Service Information

Passenger Car	Type : E 220 CDI & E 240	
Distribution : Deale	ers + Service Dealers

28th April 2000

Inspection of the air intake grill

Photographs:

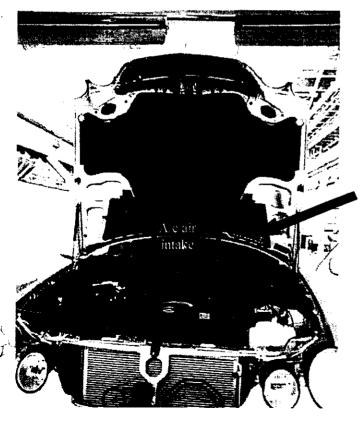
View the Bonnet top grill (EPC nomenclature is "covering -ventilation Screen"). This is located above the A/C intake-duct on the engine hood (marked by arrow). This should not be directly open to outside. In case this shows direct opening then fit the grill P. No. 210 880 08 05 and remove the grill originally fitted.

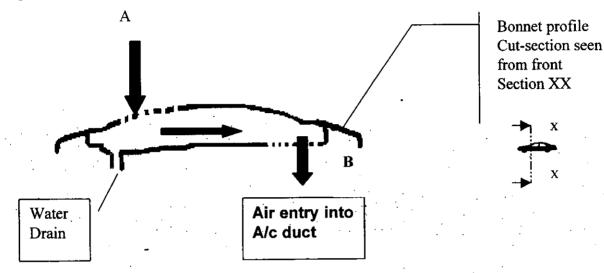
Direction of Airflow to air-conditioning system through fins on bonnet top. This is applicable for RHD vehicles.

Air entry is zig-zag to avoid water entry into A/c duct.
